Approved Development Agreement Site Plan

Lynnett Road
2 0 2 1 . 0 3 . 3 0

Lynnett Road

Approved Development Agreement Site Plan

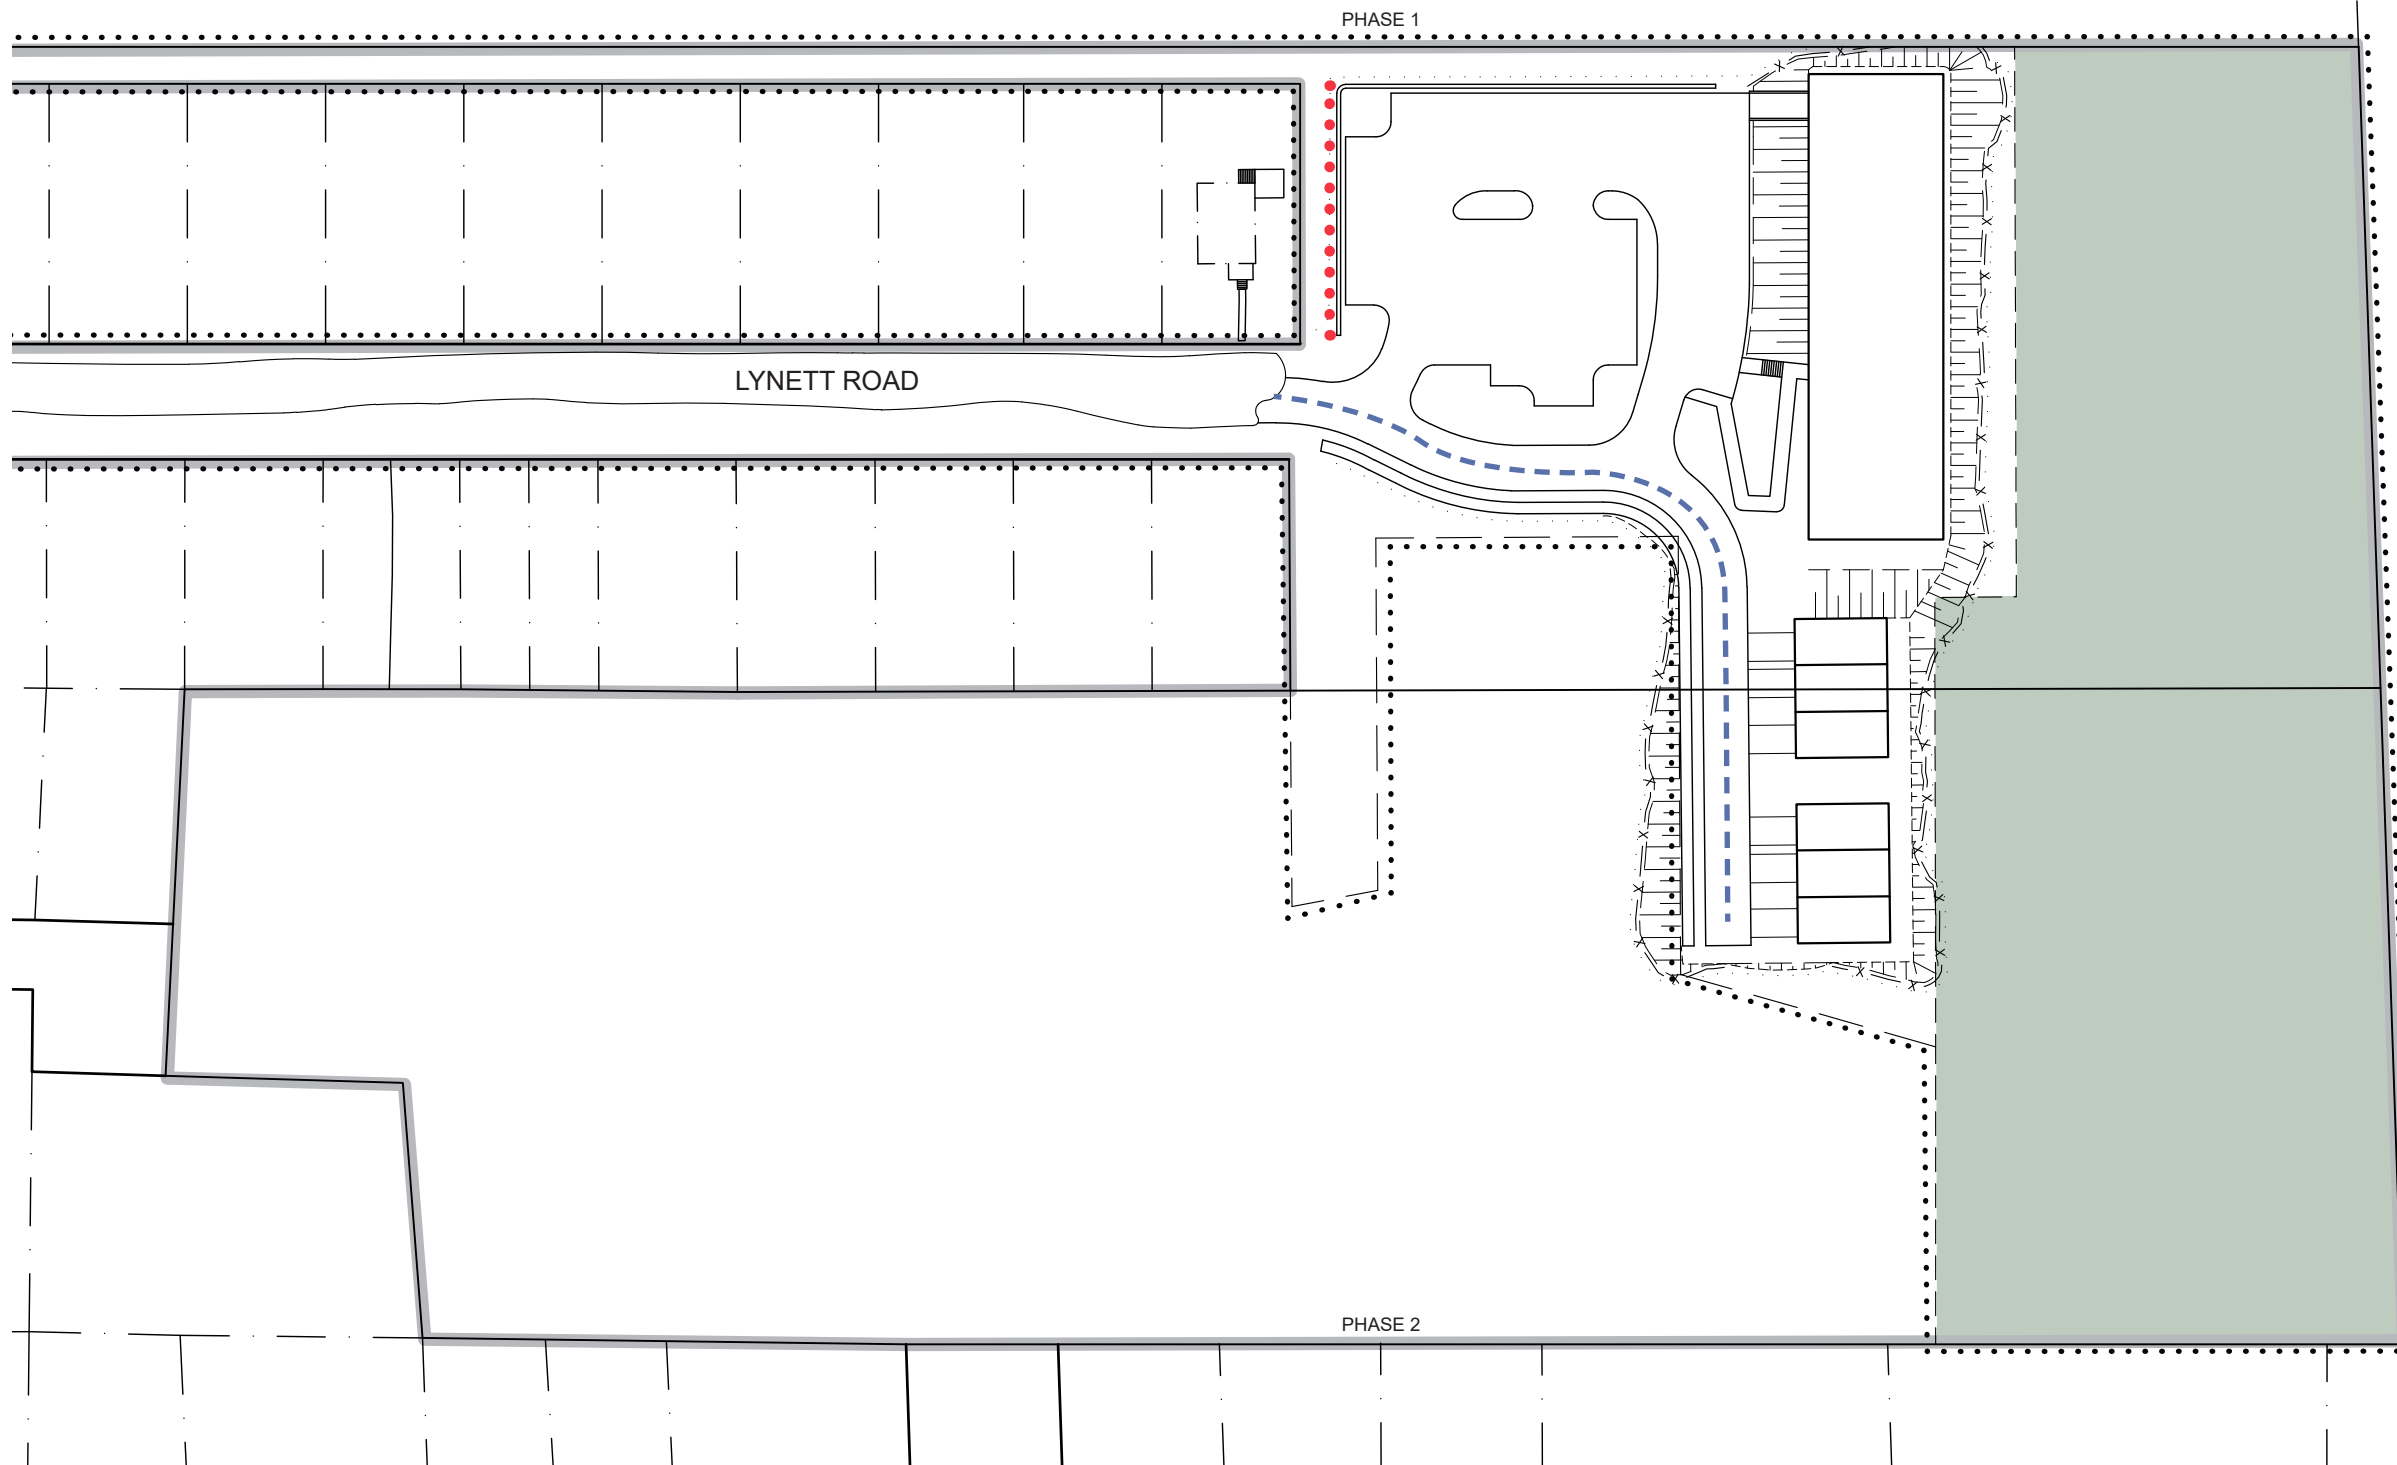
- undesirable transition from single family to multi-family dwellings
- long, steep roadway to townhouses
- long extensions for services
- 10ft retaining wall next to single family dwellings
- no turnaround at end of lynnett road
- 9350sq.m. of protected greenspace

- 10ft Retaining Wall
- - - - Road Extension Required - 120 m

Add Cul-de-Sac

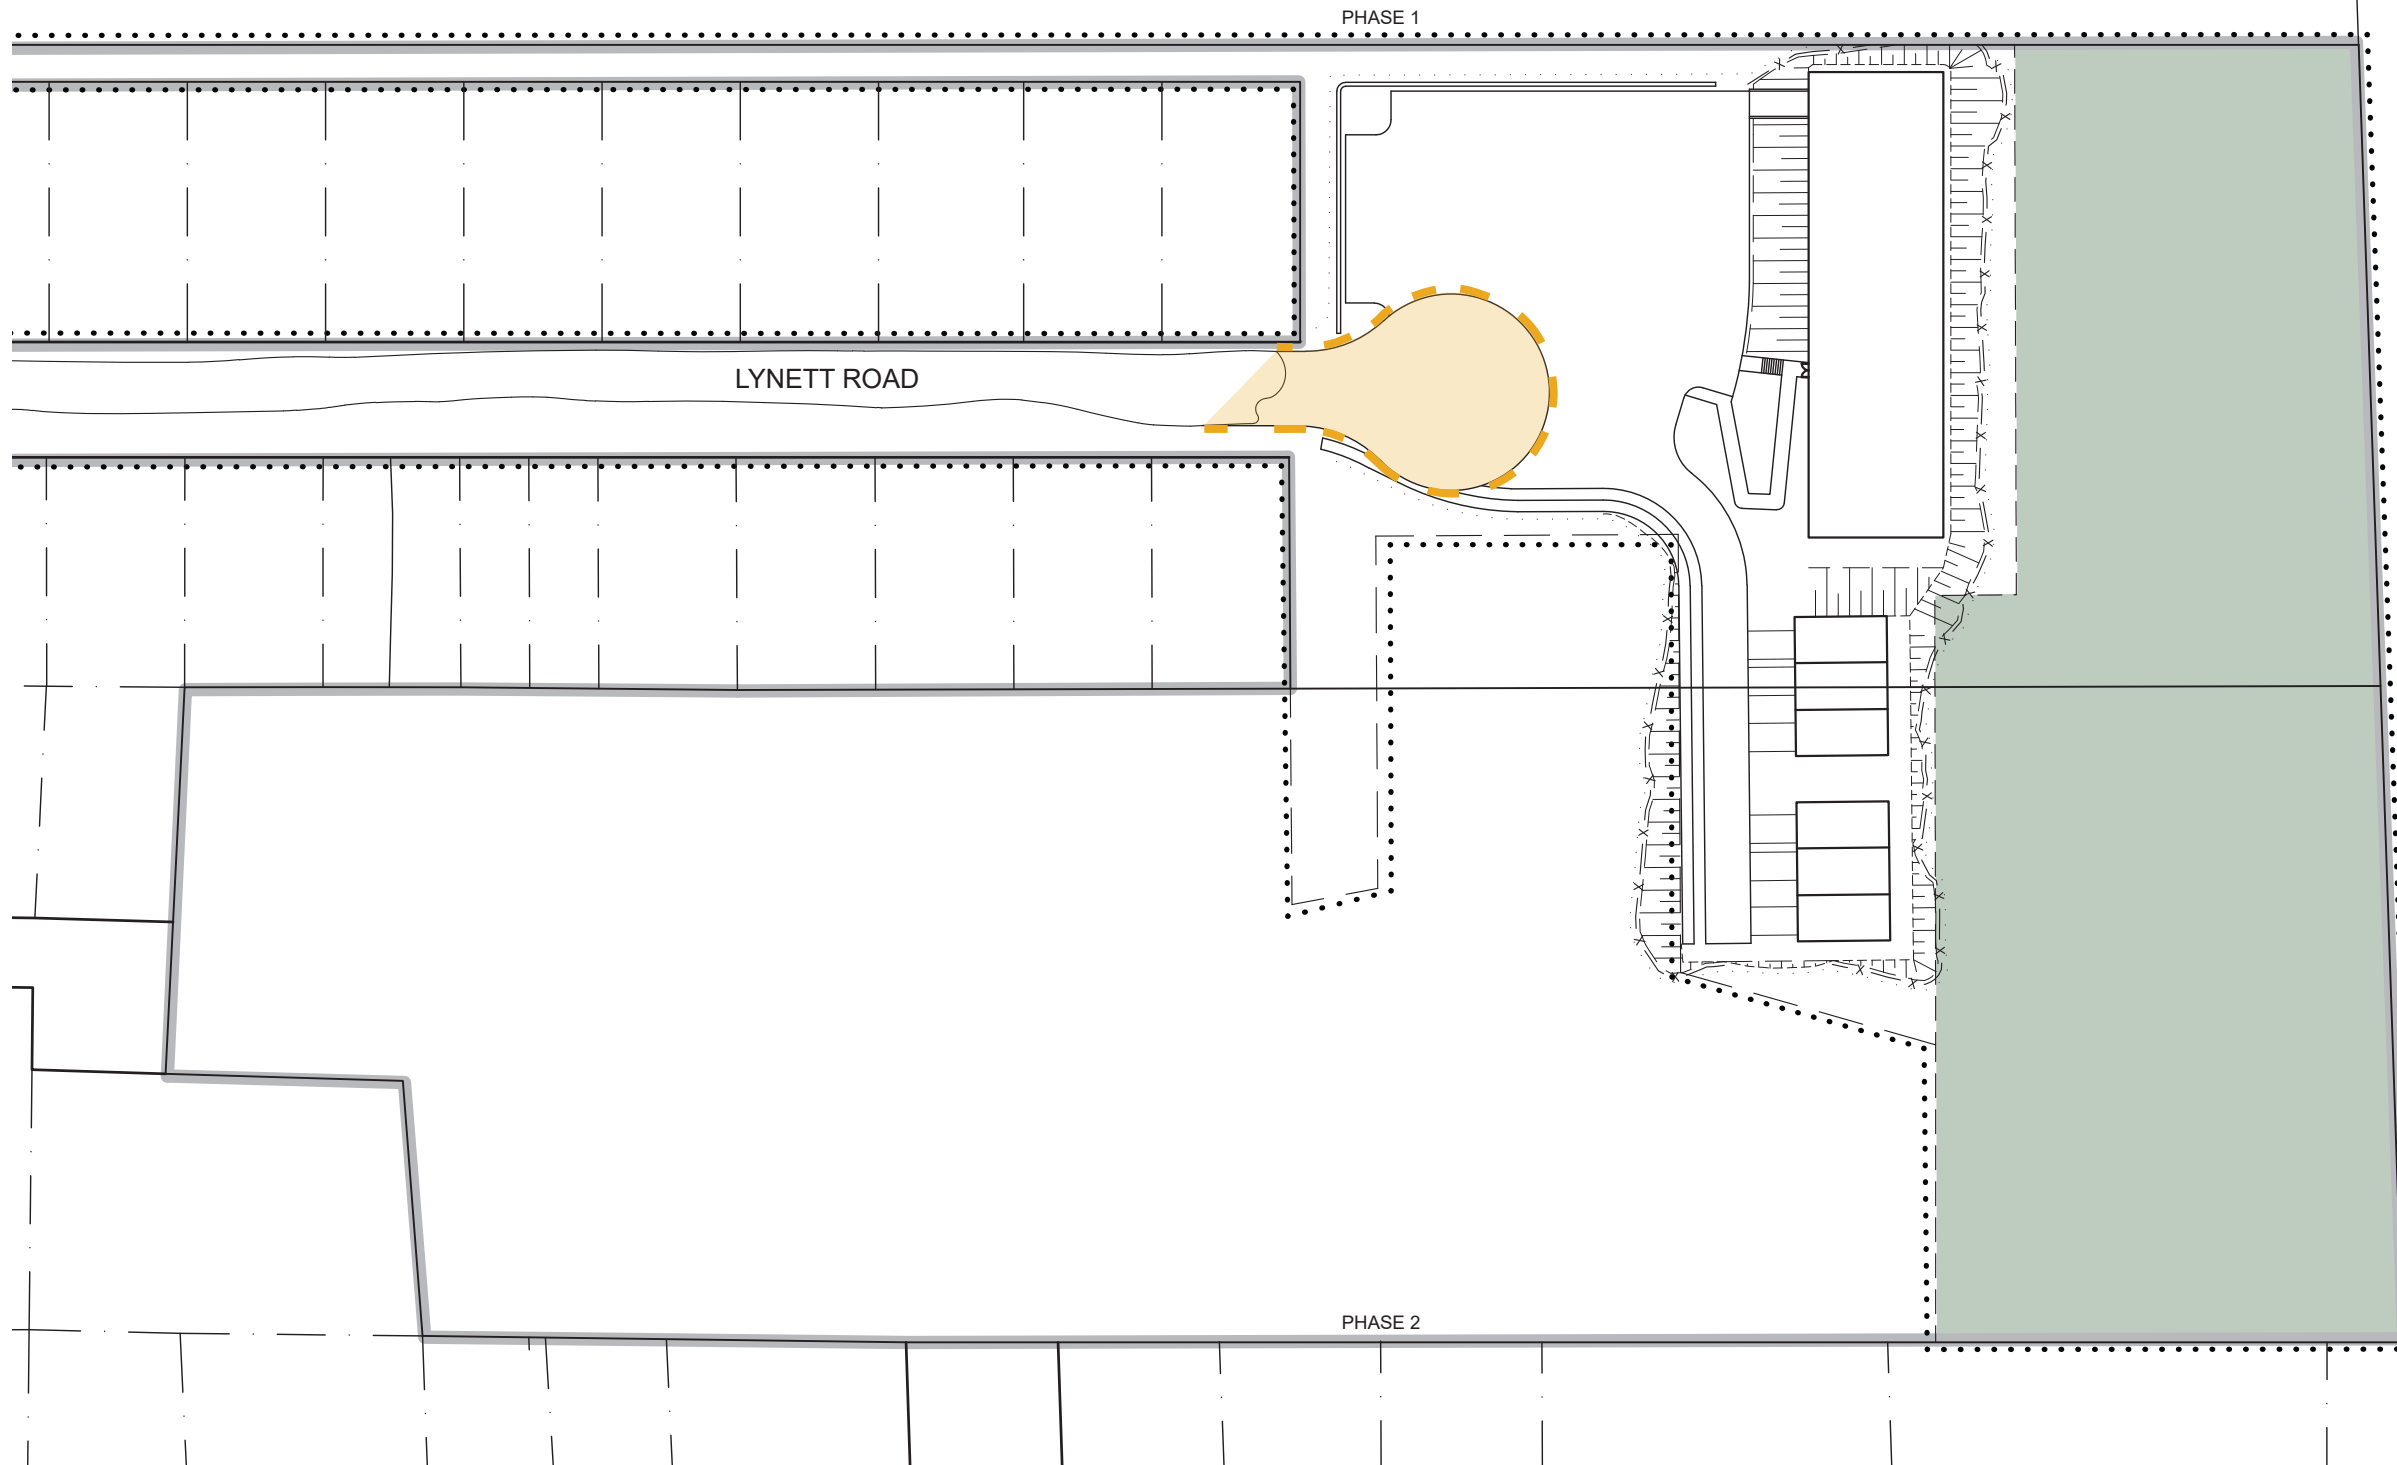
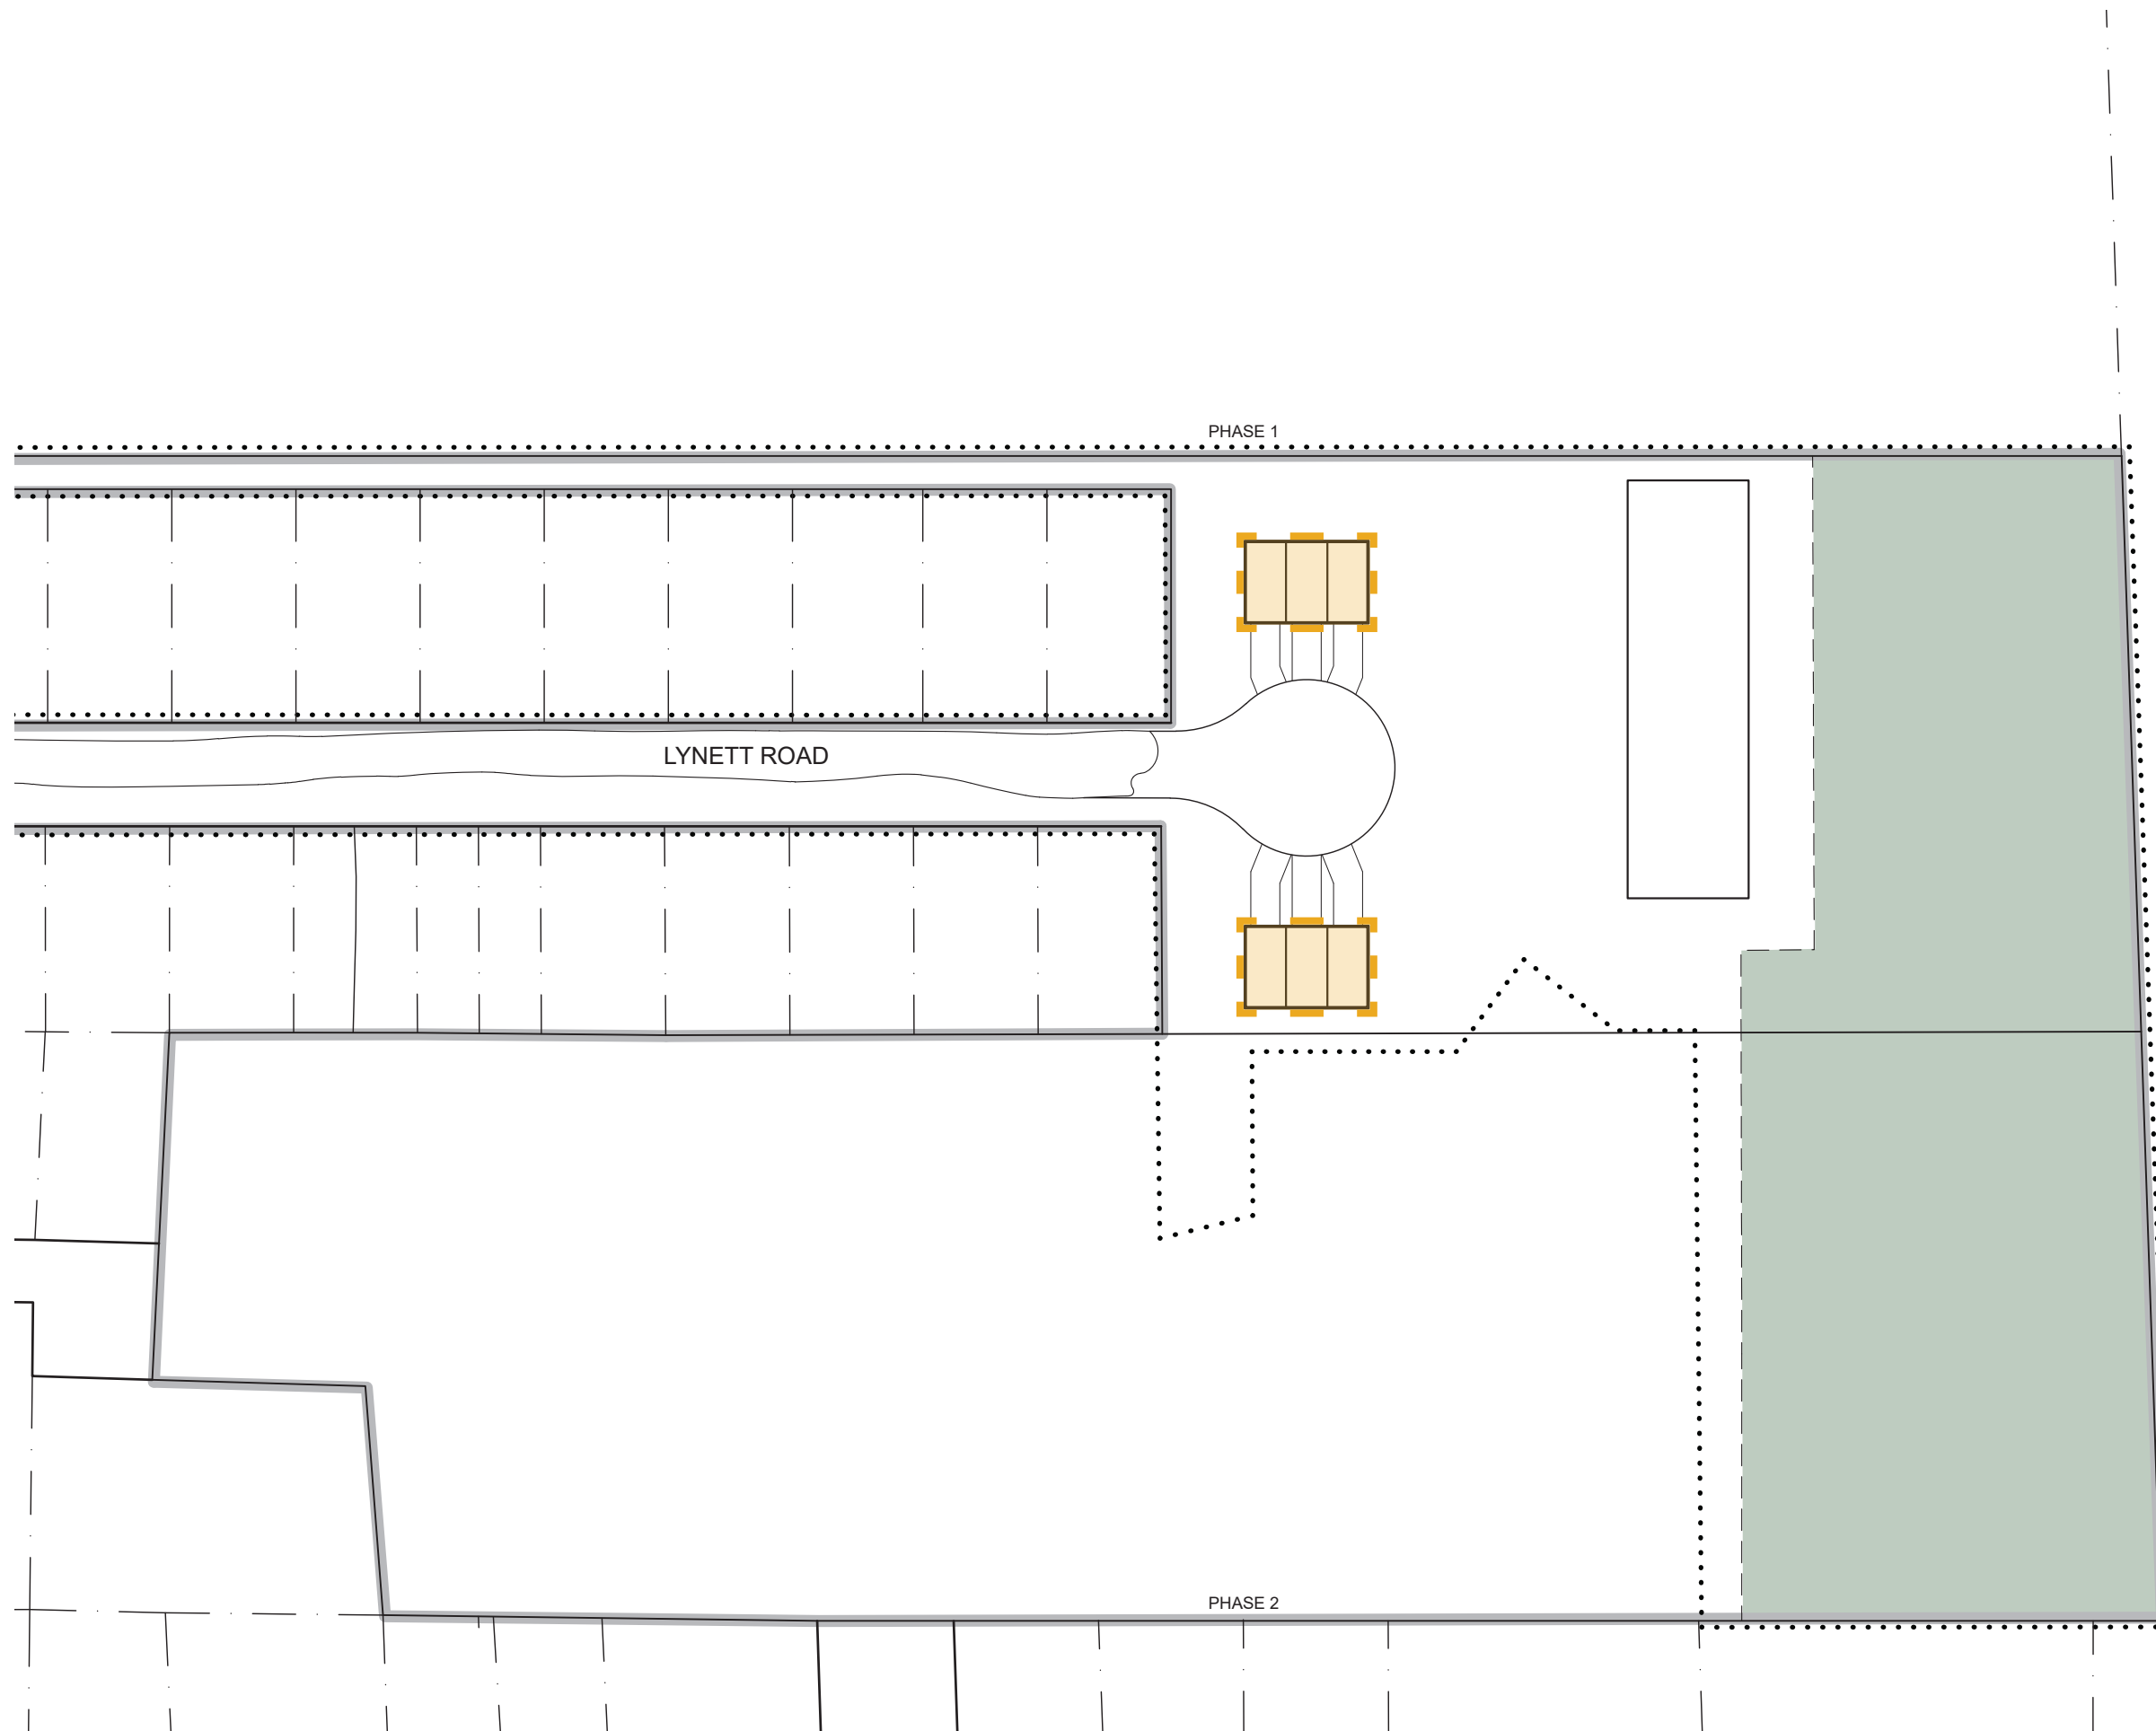
- provides turn around at end of Lynnett Road
- enables turn around for emergency vehicles
- enables turn around for neighbours
